Application for Licence Amendment

Licence Number	L9094/2017/1
Licence Holder	Water Corporation
File Number	DER2017/001655-1
Premises	Broome North Water Resource Recovery Facility Lot 1502 Crab Creek Road ROEBUCK WA 6725 Legal description – Lot 1502 on Deposited Plan 75036 Certificate of Title Volume 2805 Folio 367
Date of Report	22 December 2021
Proposed Decision	Revised licence granted

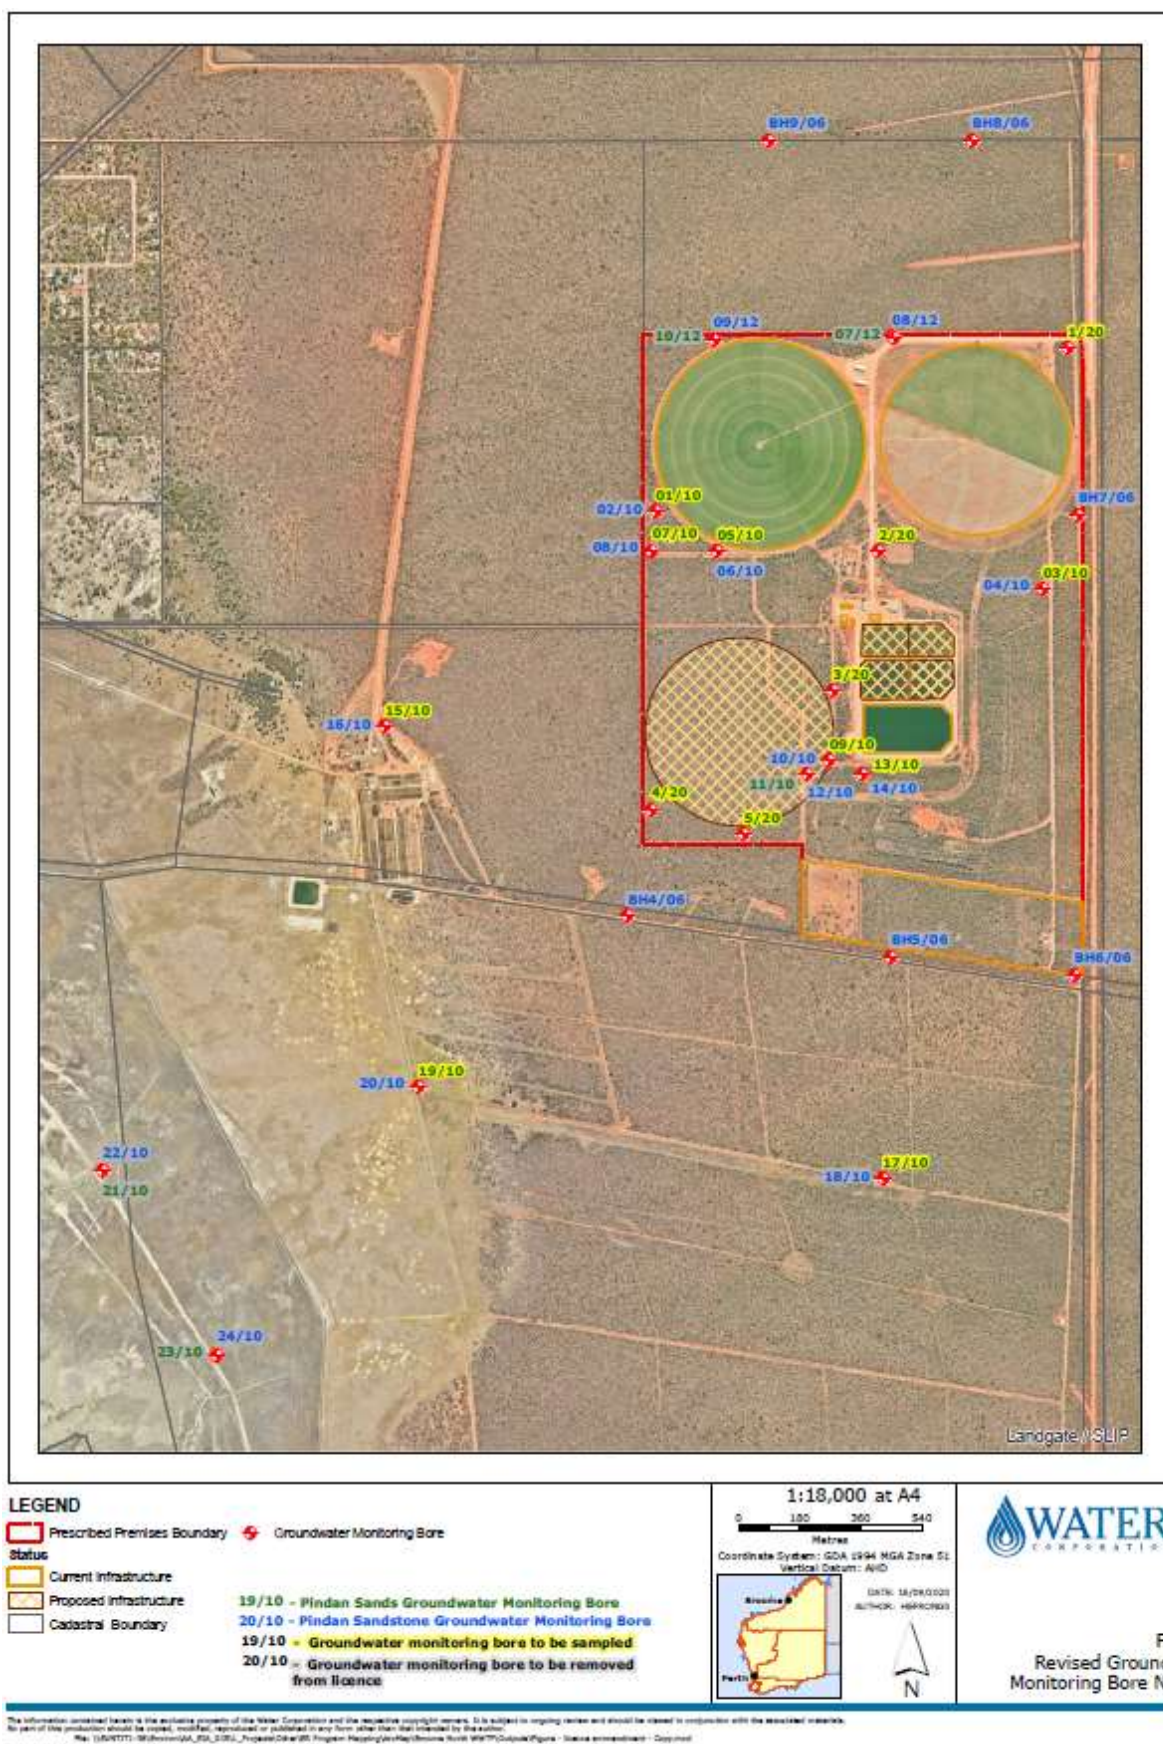
The proposed amendments to the groundwater monitoring program are to monitor only the Pindan Sands aquifer and to reduce the number of bores requiring sampling from the 30 listed on the Existing Licence to 14 bores at locations specified by the Licence Holder. Most of the bores proposed for removal are screened within the Broome Sandstone aquifer, however some bores screened within the Pindan Sands are proposed to be replaced with newly drilled wells in alternate locations. A summary of the Licence Holder's justification for the amendment is provided below:

- Monitoring of the Broome Sandstone aquifer is proposed for removal as it's considered hydraulically connected to the Pindan Sands aquifer and provides limited value above monitoring only the Pindan Sands.
- A reduction in the number of locations requiring monitoring is proposed, due to groundwater monitoring conducted to date observing stable trends in contaminant concentrations and a general consistency between background and downgradient concentrations across both aquifers.
- Bores 21/10 and 23/10, located approximately 2.5 km down hydraulic gradient from the Premises, are proposed for removal as existing on-site (4/20 and 5/20) and off-site bores (15/10 and 19/10) already provide sufficient coverage to monitor any potential downgradient impacts to groundwater.

Excluding one monitoring well located at the site of future irrigation infrastructure, the Licence Holder will retain the removed bores as a contingency for future sampling events. The existing and proposed changes to the groundwater monitoring network are shown in Figure 1 below and specific explanation for the monitoring bores to be removed from the licence are contained in Table 1.

Bore ID	Aquifer	Location	Justification for removal
BH4/06	Broome Sandstone	Offsite and south of the WWTP	Fugitive emissions resulting from WWTP operations will be captured through the monitoring of onsite bores 9/10, 11/10, 13/10, 3/20, 4/20 and 5/20, located down-hydraulic gradient of the treatment ponds and irrigation pivot 3. Bore 19/10 located offsite and further down-hydraulic gradient would also detect fugitive wastewater emissions.

Bore ID	Aquifer	Location	Justification for removal
BH5/06 BH6/06	Broome Sandstone	Offsite and south of the WWTP and tree plantation	Bores BH5/06 and BH6/06 are located down-hydraulic gradient of the MAC tree plantation. The plantation accounts for approximately 1% of irrigated treated wastewater at the Premises and would be unlikely to impact groundwater quality. Any fugitive emissions resulting from MAC plantation operation will be captured through the monitoring of offsite down-hydraulic gradient bores 17/10 and 19/10.
BH7/06 04/10	Broome Sandstone	Eastern Premises boundary	Bore 3/10 located on the eastern boundary of the site and bore 1/20 located north of pivot 2 will monitor background groundwater quality entering the Premises.
BH8/06 BH9/06	Broome Sandstone	Offsite and north of the WWTP	Bore 3/10 located on the eastern boundary of the Premises and bore 1/20 located north of pivot 2 will monitor background groundwater quality.

2/10 6/10 8/10	Broome Sandstone	Southwest of pivot 1	Fugitive emissions from pivot 1 will be captured through the monitoring of bores 1/10, 5/10 and 7/10 screened within the Pindan Sands.
10/10 12/10 14/10	Broome Sandstone	Southwest of the treatment ponds	Monitoring of bores 9/10, 13/10 and 3/20 will capture any potential fugitive emissions from operation of the treatment ponds.
11/10	Pindan Sands	Southwest of the treatment ponds	The bore is likely to be destroyed in the near future during the construction of irrigation pivot 3. Monitoring of bores 9/10, 13/10 and 3/20 will capture any fugitive emissions from operation of the treatment ponds.
16/10	Broome Sandstone	Offsite and 1.4 km west of the treatment ponds	Any fugitive emissions from the operation of the WWTP will be captured through the monitoring of on-site bores 1/10, 5/10, 7/10, 4/20 and 5/20, and off-site bores 15/10, 17/10 and 19/10.

18/10 20/10	Broome Sandstone	Offsite south and southwest of the Premises	
21/10 22/10 23/10 24/10	Pindan Sands (21/10, 23/10) Broome Sandstone (22/10, 24/10)	Offsite and 2.5km southwest of the treatment ponds	Any fugitive emissions from the operation of the WWTP will be captured through monitoring of bores screened within the Pindan Sands through existing onsite bores 4/20 and 5/20, and closer offsite bores 15/10 and 19/10, that are located down hydraulic gradient of the WWTP.

Figure 2: Distance to sensitive receptors. The Premises boundary is shown in pink.

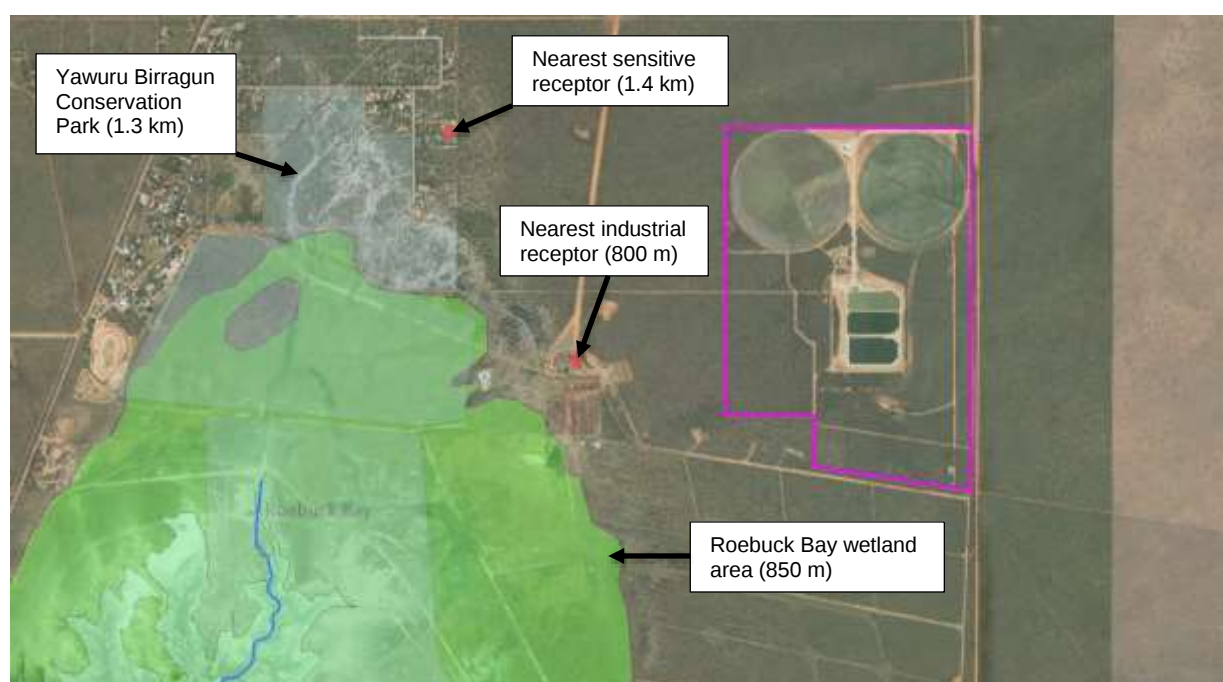
Receptors	Distance from prescribed activity
Human receptors	
Sensitive receptor – Morrell Park aboriginal community homestead	1.4 km west of the Premises boundary and 1.5 km west of the nearest irrigation area.
Industrial receptor – Cattle saleyard office/sheds	800 m west of the Premises boundary and 1.4 km west of the nearest pond infrastructure.
Environmental receptors	
Underlying groundwater – Pindan Sands aquifer Broome Sandstone aquifer	Groundwater monitoring conducted by the Licence Holder indicates that the two aquifers are hydraulically connected in the area, as the lower part of the Pindan Sands is difficult to distinguish from the upper Broome Sandstone (GHD 2020a). This is consistent with the existing regional interpretation that the Pindan Sands and Broome Sandstone are hydraulically continuous and considered to be a single unconfined groundwater resource in the Broome area (DOW 2012). Annual reporting for the 2019/2020 period recorded the following depths to groundwater at the Premises and offsite monitoring network: - Pindan Sands aquifer: 5.90 – 6.05 mbgl (3.1 – 5.95 m AHD) - Broome Sandstone aquifer: 5.75 - 17.80 mbgl (2.49 – 4.95 m AHD) Regional information indicates that groundwater flow is in a southwesterly direction towards Roebuck Bay and Dampier Creek, with a hydraulic gradient of approximately 0.001. No licensed/registered groundwater abstraction bores are located within 1 km of the Premises (based on available GIS dataset –WIN Groundwater Sites).

Receptors	Distance from prescribed activity
Important wetlands – Roebuck Bay	The Roebuck Bay wetland area is approximately 850 m southwest of the Premises boundary, 1.1 km southwest of the nearest irrigation area and 1.5 km southwest of the treated wastewater storage pond. Dampier Creek is considered part of the Roebuck Bay wetland.
Surface water – Dampier Creek	Permanent surface water of Dampier Creek is located approximately 2 km southwest of the Premises boundary, 2.4 km southwest of the nearest irrigation area and 2.75 km southwest of the treated wastewater storage pond.
Department of Biodiversity, Conservation and Attractions legislated tenure – Yawuru Birragun Conservation Park	1.3 km west of the Premises boundary and 1.45 km west of the nearest irrigation area.
RAMSAR Wetland - Roebuck Bay Site ID: 479	The defined area of the Roebuck Bay RAMSAR wetland is located approximately 5.5 km southeast of the Premises boundary.

Threatened Ecological Communities (TEC) - Species-rich faunal community of the intertidal mudflats of Roebuck Bay	The Premises is situated within the buffer area of the TEC. The TEC is listed as vulnerable under the <i>Biodiversity Conservation Act 2016</i> (WA) (BC Act).
Threatened Ecological Communities (TEC) - Monsoon (vine) thickets on coastal sand dunes of the Dampier Peninsula	The TEC includes the coastal inundation areas surrounding Dampier Creek, the upper reaches of which are approximately 900 m southwest from the Premises boundary, 1.1 km southwest of the nearest irrigation area and 1.5 km southwest of the treated wastewater storage pond. The TEC is listed as vulnerable under the <i>Environment Protection and Biodiversity Conservation Act 1999</i> (Commonwealth) (EPBC Act).
Public Drinking Water Source Area - Broome Water Reserve (P1)	2.4 km north and upgradient of the Premises boundary.
